GULF STATES UTILITIES COMPANY

January 24, 1985
RBG- 19,971
File No. G9.5

River Bend Station-Unit 1
Docket No. 50-458

Enclosed is a revision to Chapters 13.1, 13.2, 13.4 and 13.5 of Gulf States Utilities Company (GSU) River Bend Station (RBS) Final Safety Analysis Report (FSAR). These revisions are the reflection of the organizational changes effective December 10, 1985 and will be incorporated into the next FSAR Amendment.

FIGURE 13.1-6
~~PLANT OPERATIONS STRUCTURE~~
~~RIVER BEND STATION UNIT 1~~
RIVER BEND STATION
FINAL SAFETY ANALYSIS REPORT

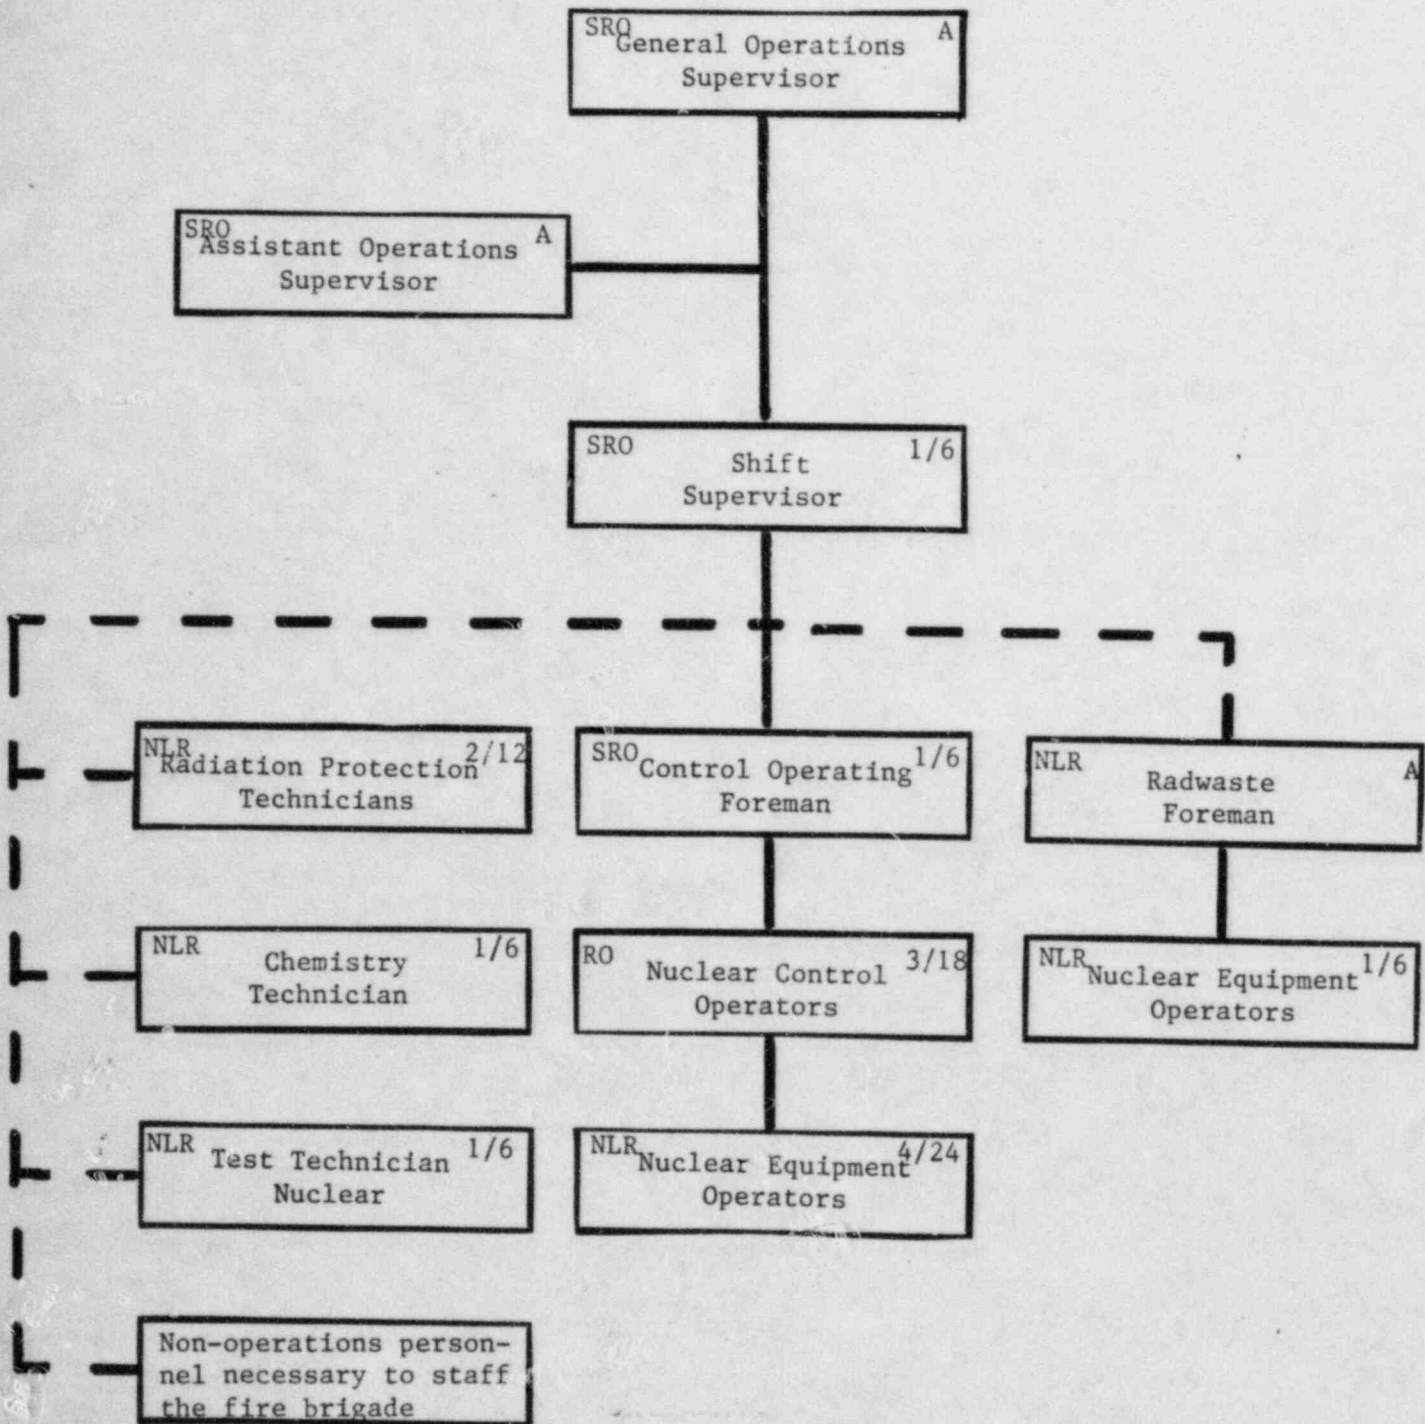
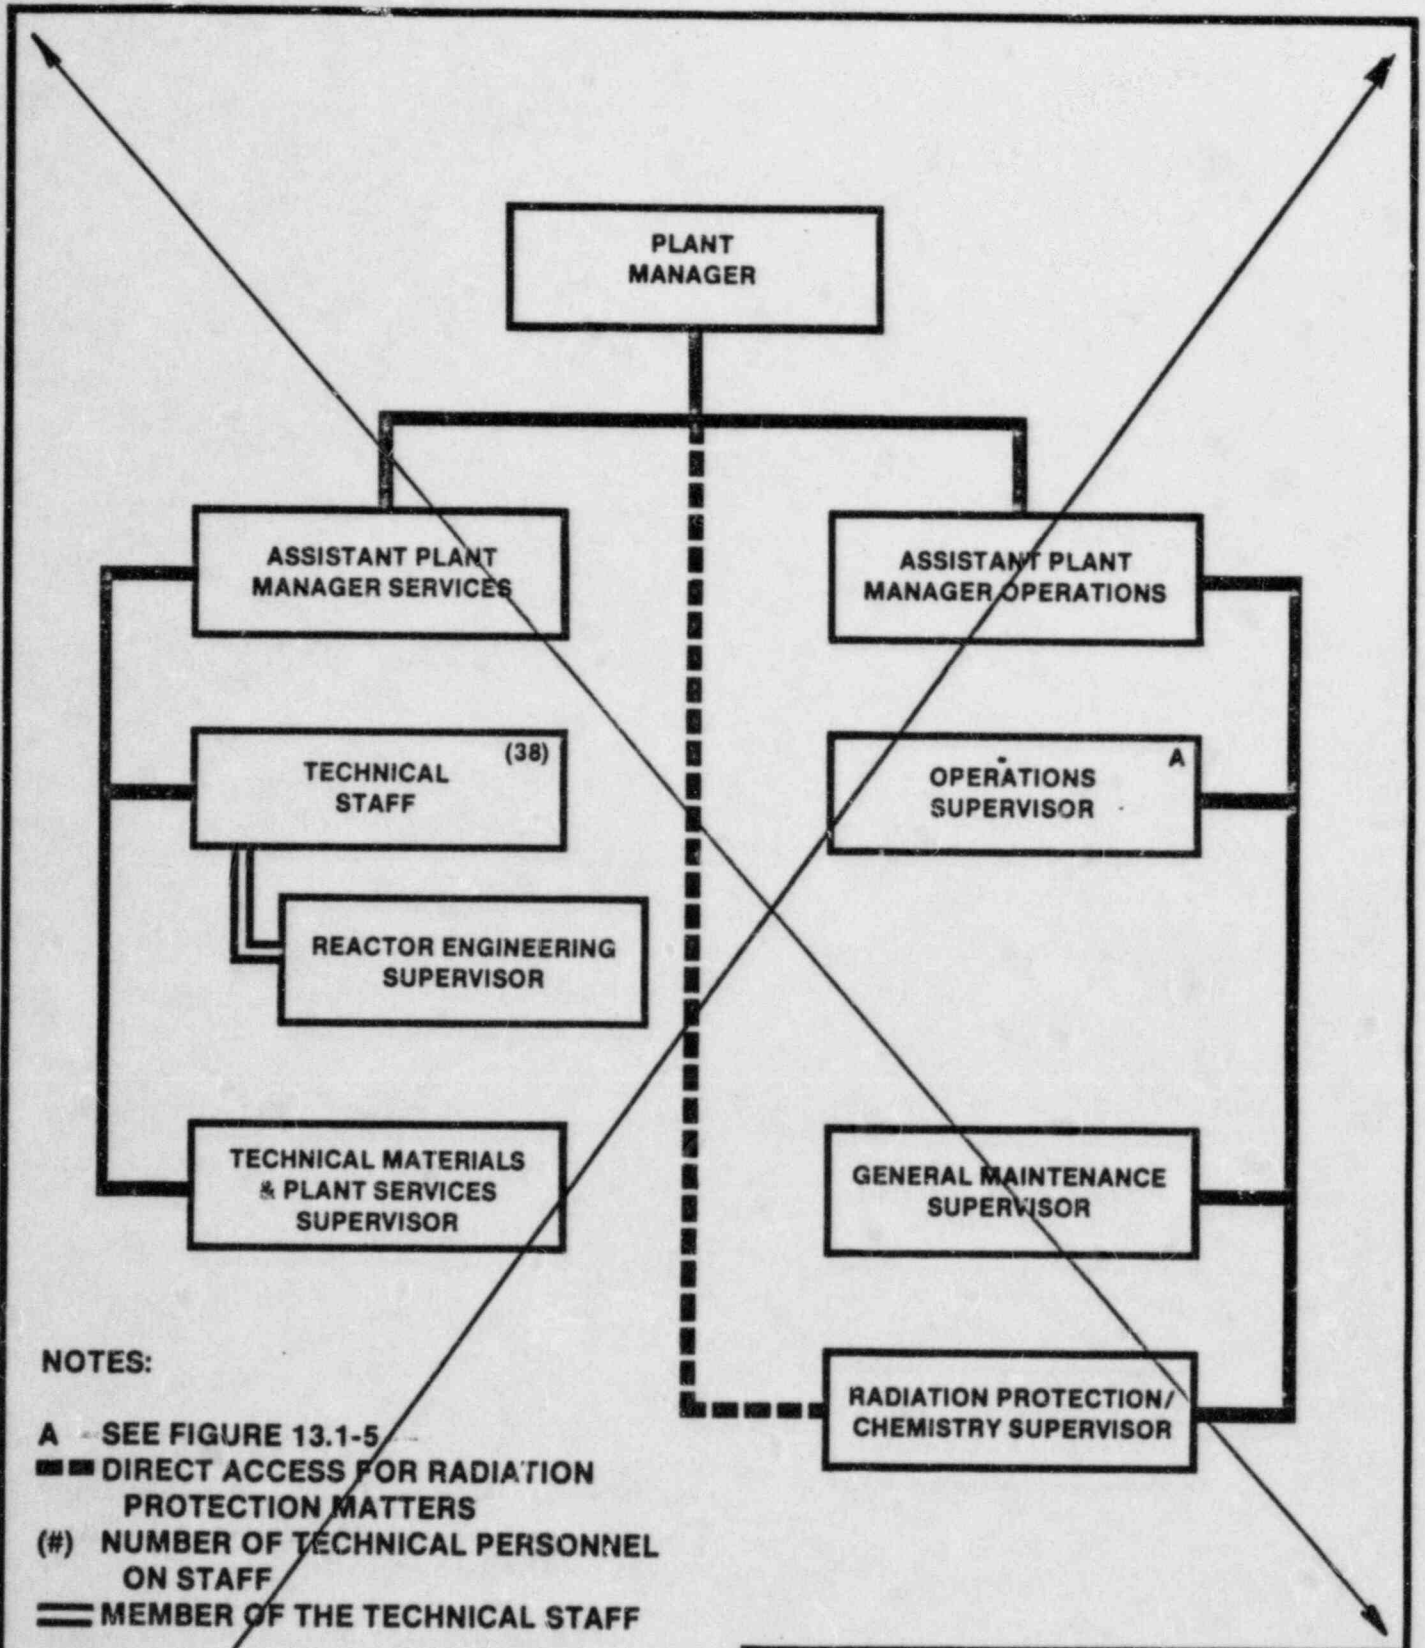
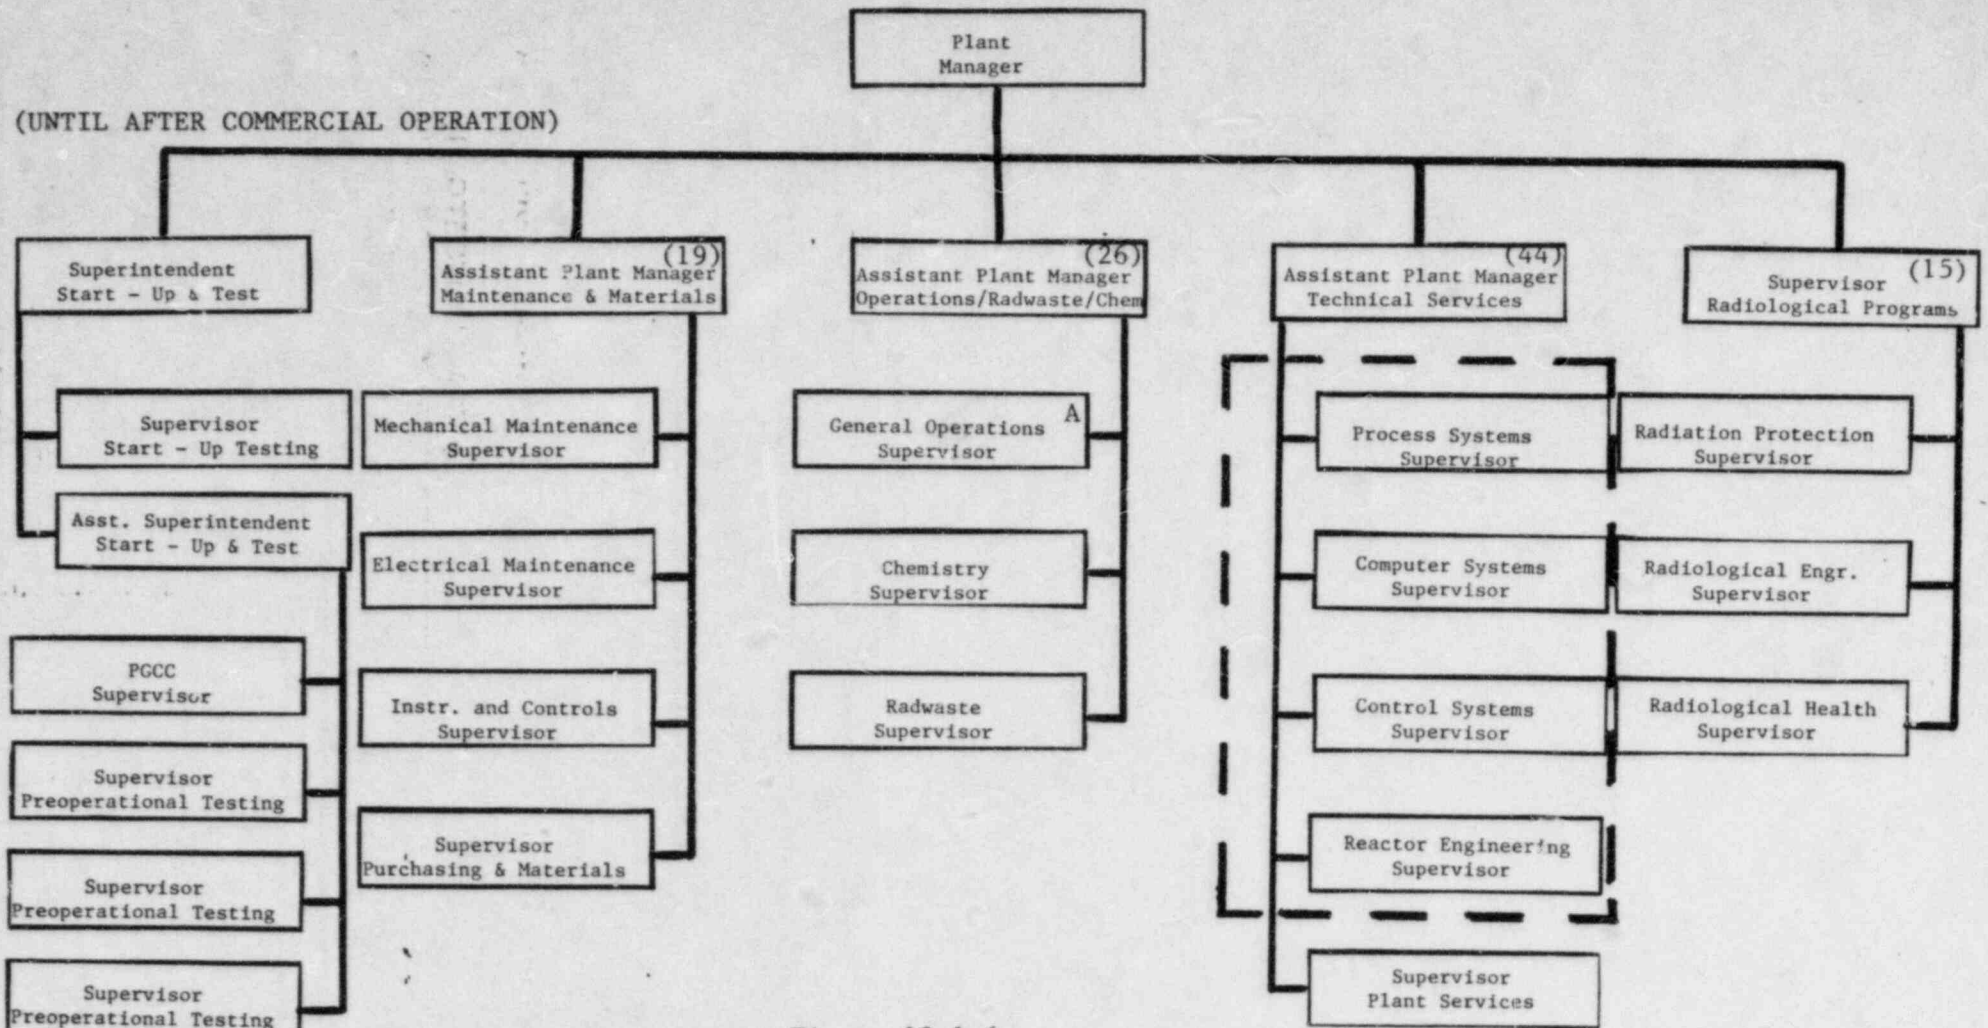
- D.) Manager-Administration
9. Regarding the Plant Staff organization three Assistant Plant Managers (APMs) and the new position of Supervisor-Radiological Programs report directly to the Plant Manager. The Supervisor-Radiological Programs replaces the Radiation Protection/Chemistry Supervisor and retains all responsibilities except for sampling and analysis of plant fluid systems. The function becomes part of the Chemistry Section which along with Operations and Radwaste report to the APM-Operations, Radwaste and Chemistry. Still reporting to the APM-Technical Services is the Technical Staff and the Plant Services Group. This latter group replaces the Technical Materials and Plant Services Group and retains all responsibilities except for materials controls. Purchasing and materials duties are now under the direction of the Assistant Plant Manager - Maintenance and Materials along with general maintenance functions (see Item 4 above.)

DELETE AND
REPLACE WITH
REVISED FIGURE

Figure 13.1-6
River Bend Station
Plant Operations Structure
